Proposal for Supplement 7 to the 01 series of amendments to Regulation No. 112 (Headlamps emitting an asymmetrical passing-beam)

Submitted by the expert from the International Automotive Lighting and Light Signalling Expert Group (GTB)*

Annex 2, figures 5, 6, 7, 8, 9 and 10, amend to read:

Figure 5: Class A for ~~both traffic systems~~ **left-hand traffic only**.

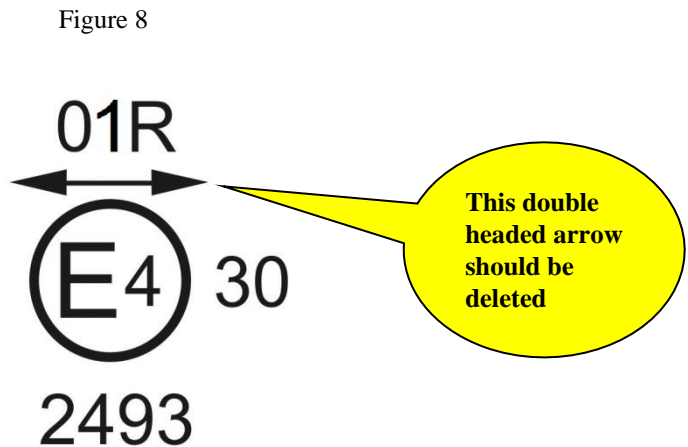
Figure 6: Class B for ~~right hand traffic only~~ **both traffic systems**.

Figure 9

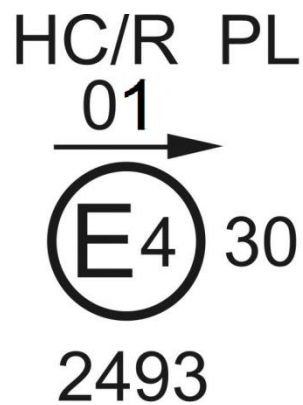
Figure 9: Class B in respect to both the passing-beam and driving-beam and designed for ~~right-hand~~ **left-hand** traffic only.
